UNITED STATES PATENT AND TRADEMARK OFFICE

APPLICATION NO.	FILING DATE	FIRST NAMED INVENTOR	ATTORNEY DOCKET NO.	CONFIRMATION NO.
09/801,695	03/09/2001	Toshiro Hayakawa	Q61191	3297

Office Action Summary

DETAILED ACTION

FIG. 1

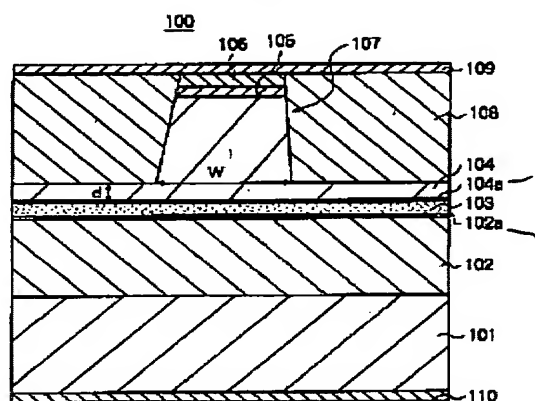
Claim 8 is rejected under 35 U.S.C. 102(e) as being anticipated by Hirata (PN 6,195,375).

Figure 1 illustrates a semiconductor laser having lower and upper cladding layers (102), (104), an active layer (103), lower and upper guide layers (102a) and (104a)

where the upper guide layer has a thickness smaller than the lower guide layer and a stripe width (W) of $0.4\text{ }\mu\text{m}$ or less, as described in the abstract and columns 6 and 7.
